REMARKS

Rejection Over U.S. Application Publication No. 2002/0178997 to Tsui-Hua

Fig. 2

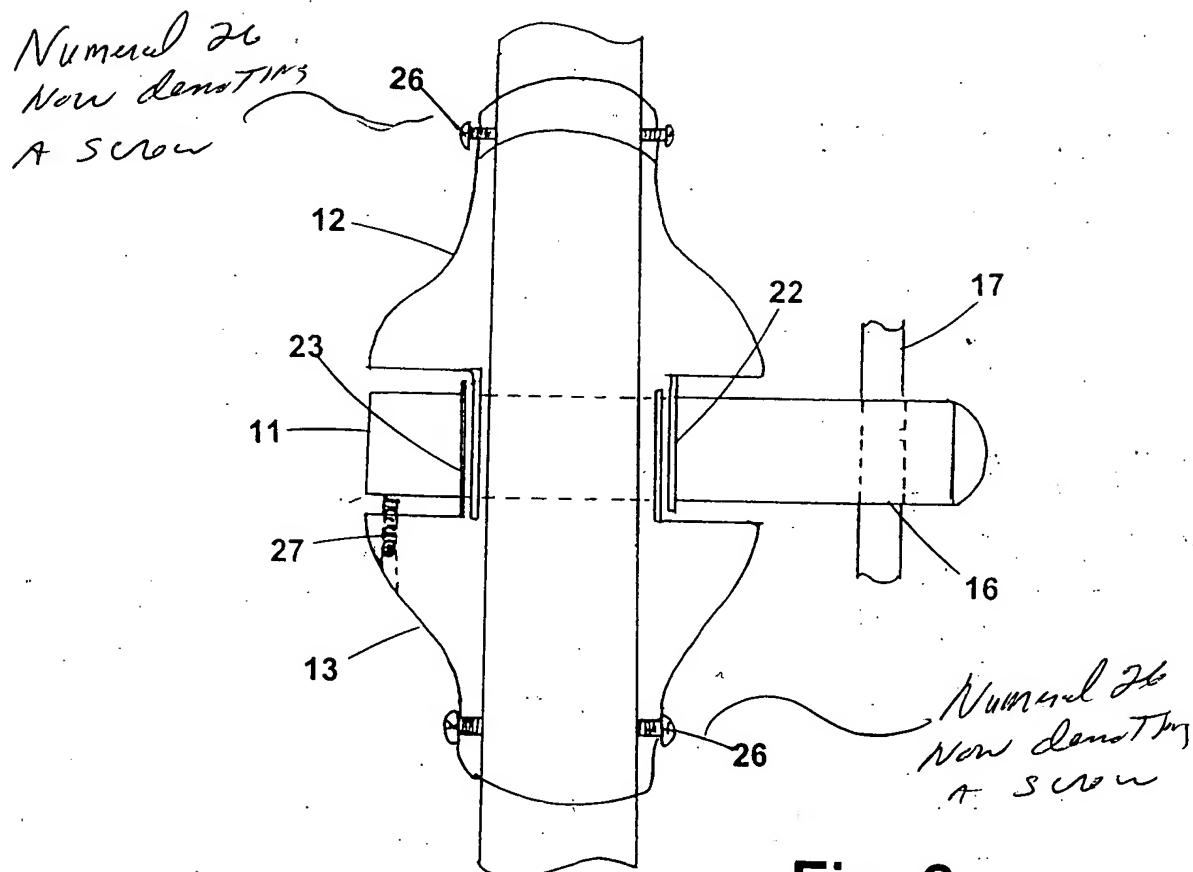
In amended Figure 2, the numeral 26 has been amended to denote the screws that may be hand tightened.
